RARITAN ESTATES REDEVELOPMENT

ZONE MAP AMENDMENT & PUD WRITTEN EXPLANATION

The following review comments and information from the Development Review Team is based on the information you submitted for a preliminary development plan, preliminary plat, waivers, and vacation. The Development Review Team review comments may change if you provide different information during the next submittal/ building permit. Please contact the case manager if you have any questions.

PLANNED UNIT DEVELOPMENT / PRELIMINARY DEVELOPMENT PLAN

T. WAIVERS

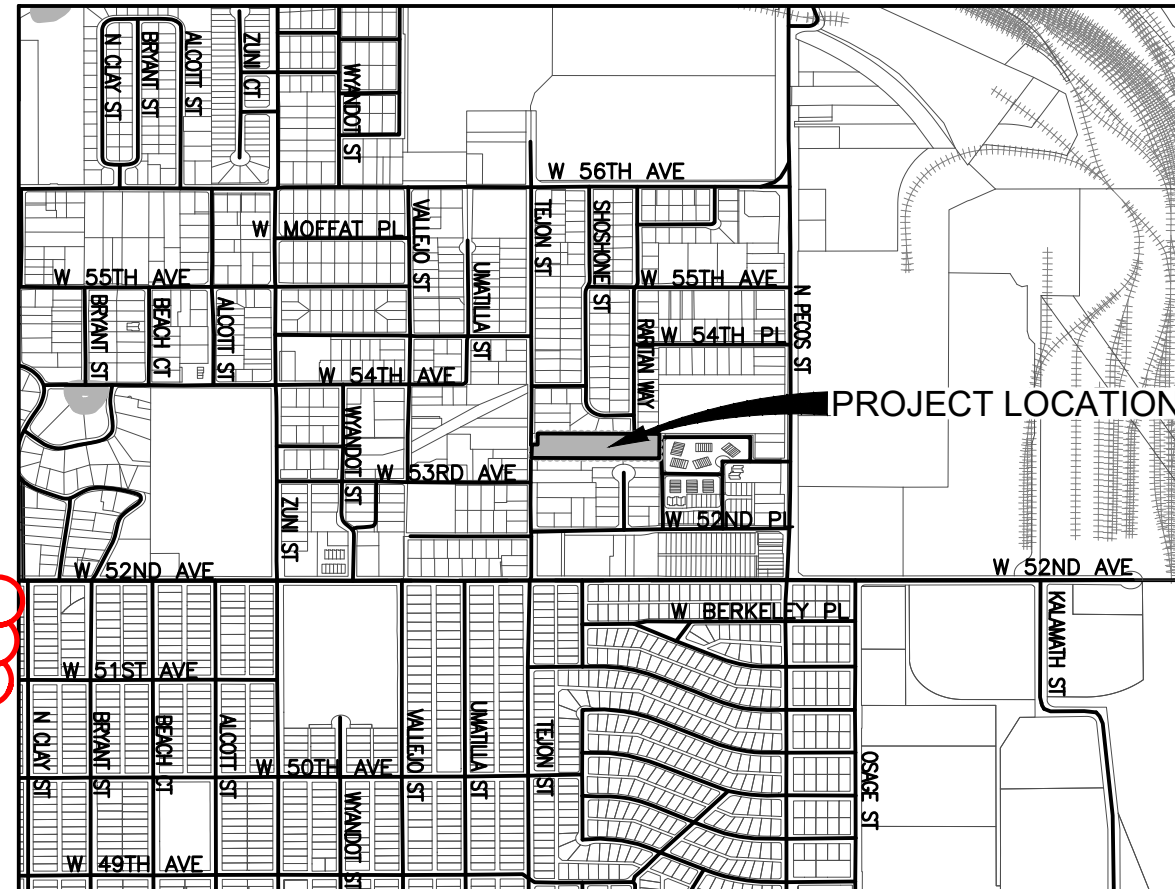
PLN11: Page 2, Section S- Landscaping can be conceptual at the PDP stage, but staff does have concerns pertaining to screening for adjacent neighbors. Also, you are not requesting a wavier from the front setback tree plantings, so please remove this language. I am not sure what this is in reference to?

PLN12: Page 2, Section T- This should be removed from the PDP and added to the written narrative.

RIGHT OF WAY AND OPEN SPACE LANDSCAPING SHALL BE PROVIDED IN ACCORDANCE WITH COUNTY STANDARDS. ON-LOT RESIDENTIAL LANDSCAPING SHALL BE PROVIDED AS NOTED BELOW IN CONJUNCTION WITH A WAIVER REQUEST REGARDING REQUIRED FRONT SETBACK TREE PLANTINGS.
